# E C O L O G I C A L   R E V I E W

## **Rockefeller Refuge Gulf Shoreline Stabilization**

(State No. ME-18)

This document reflects the project design as of the 95% Design Review meeting, incorporates all comments and recommendations received following the meeting, and is current as of October 4, 2005.

Figure 2. Design layout for test sections (Shiner Moseley and Associates, Inc. 2005).

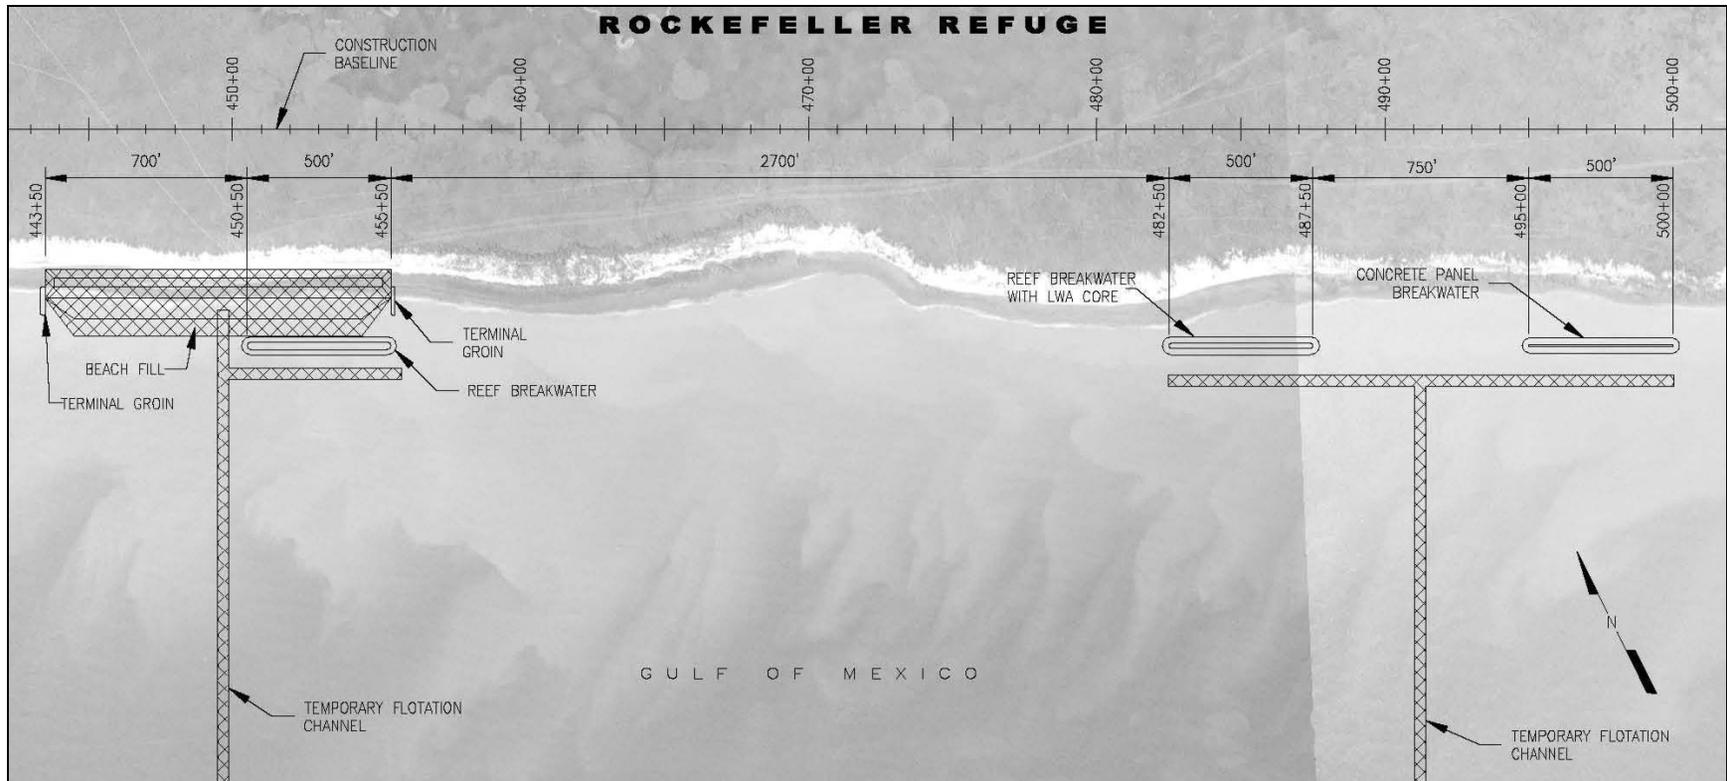
The design and layout of the test sections appear to be acceptable. In the Lake Salvador Shore Protection Demonstration project, the treatments were not randomly placed along the shoreline, and their close proximity to one another resulted in noticeable treatment interactions. As a result, statistical testing of the data was not possible and definitive conclusions regarding the treatments' influence on shoreline erosion rates could not be drawn. For the Rockefeller Refuge Gulf Shoreline Stabilization project test sections reviewed in this document, Shiner Moseley and Associates, Inc. (2005) considered wave diffraction for spacing of the breakwater alternatives, and estimated that a breakwater spacing that exceeds five times the wavelength will allow the breakwaters to function independently of each other. In addition, the excessive distance from the shoreline that led to the reduced effectiveness on past projects has been addressed in this project. Consideration was given to knowledge that to prevent any potential wave regeneration between the breakwater and the shoreline, a fetch of 200 feet or less would effectively limit the erosive waves that could harm an un-vegetated shoreline (Shiner Moseley and Associates, Inc. 2005).

Random variability in local geological conditions may affect the test results more than would any differences among the competing designs. Without replication (building more than one of each design) the relative effectiveness of the designs is essentially unknowable. Monitoring a control area, although worthwhile, does not improve this data gap. Recent aerial surveys show that shoreline erosion rates vary by more than fifteen feet per year over short distances in the vicinity of the test area (Shiner Moseley and Associates, Inc. 2005). The geotechnical survey reports spatial variability in the mechanical properties of the soils that may affect subsidence more than would the differences in breakwater construction (Shiner Moseley and Associates, Inc. 2005). Therefore, limitations exist in interpreting the results of data obtained from monitoring the test sections of this endeavor.
